GJS Plot F, Manchester

Non-material Amendment | 10.07.2024

Z1-SHP-A180-RP-XX-NMA02 | P01

3c. Proposed amendment to door side panels:

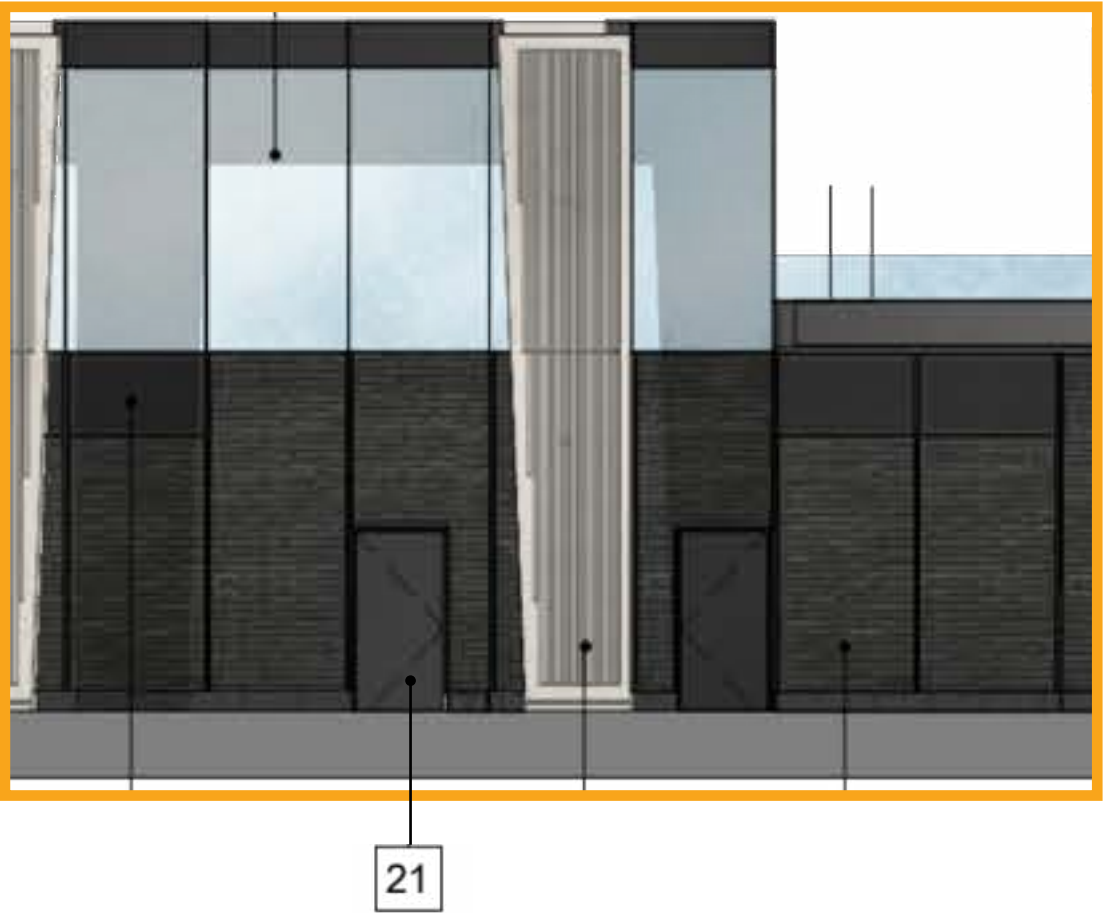
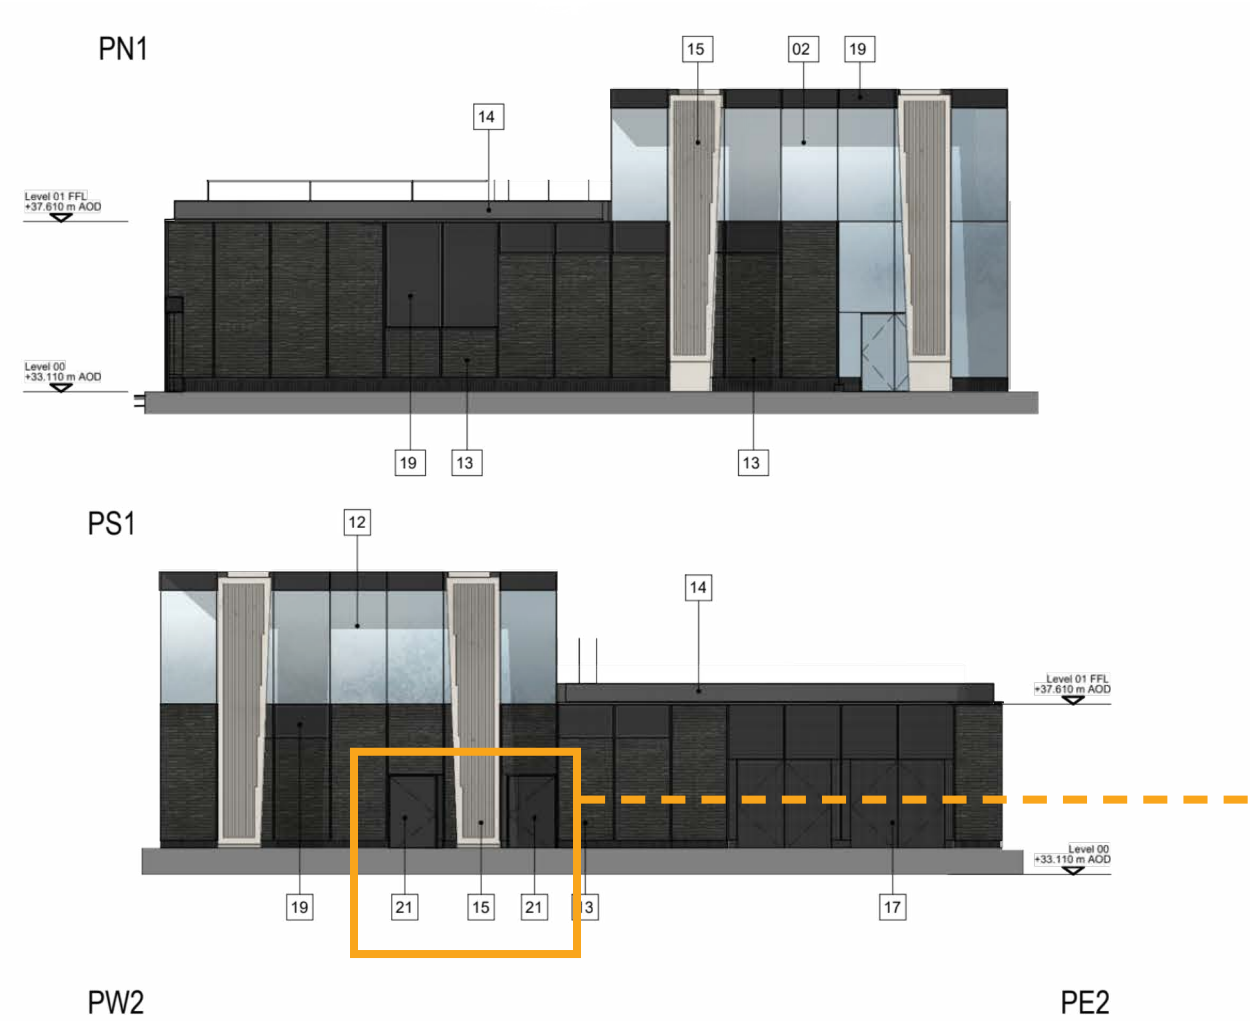
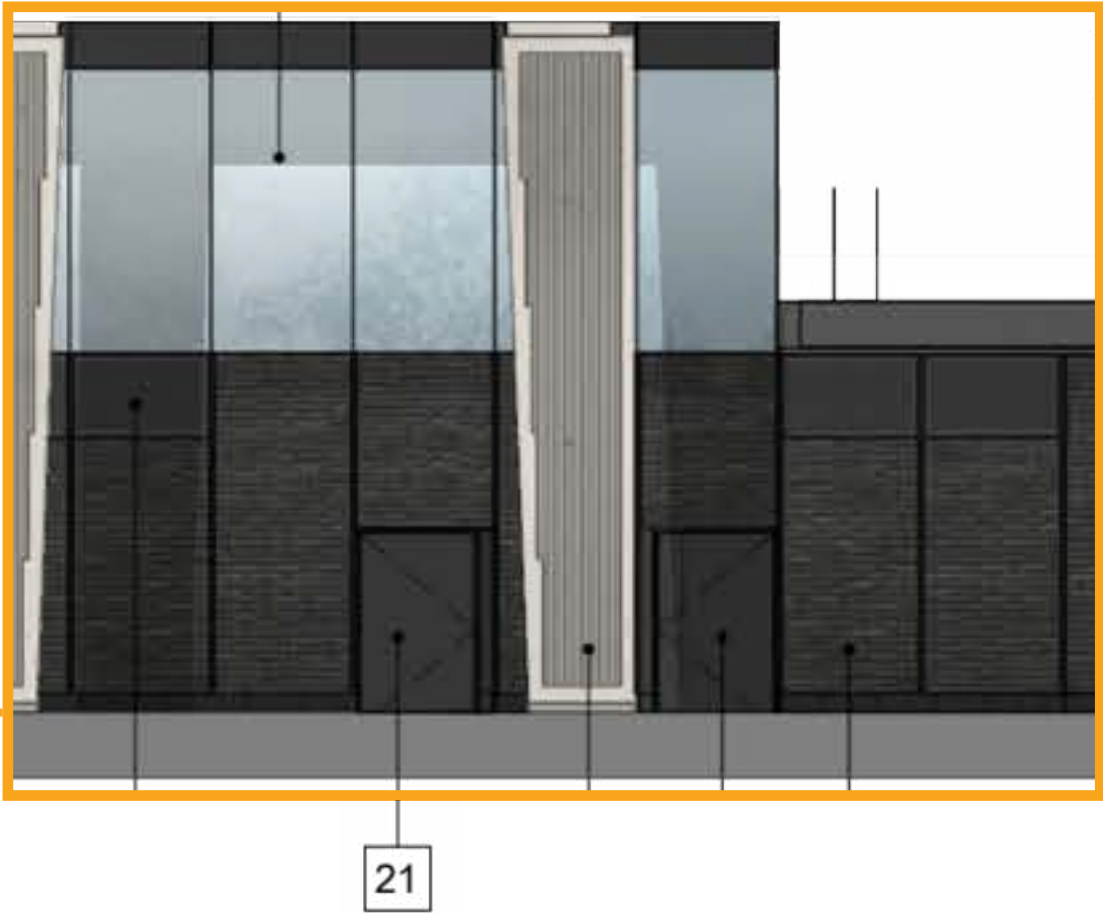
Due to an increase in the required structural opening of the door to facilitate the required clear width for the escape doors. It is no longer feasible to have brick to the side of the door.

Instead a solid anodised panel will be introduced to match the door, this will help to enforce the panelised language of the podium facade.

21. Solid anodised door (dark grey) with matching side panel.
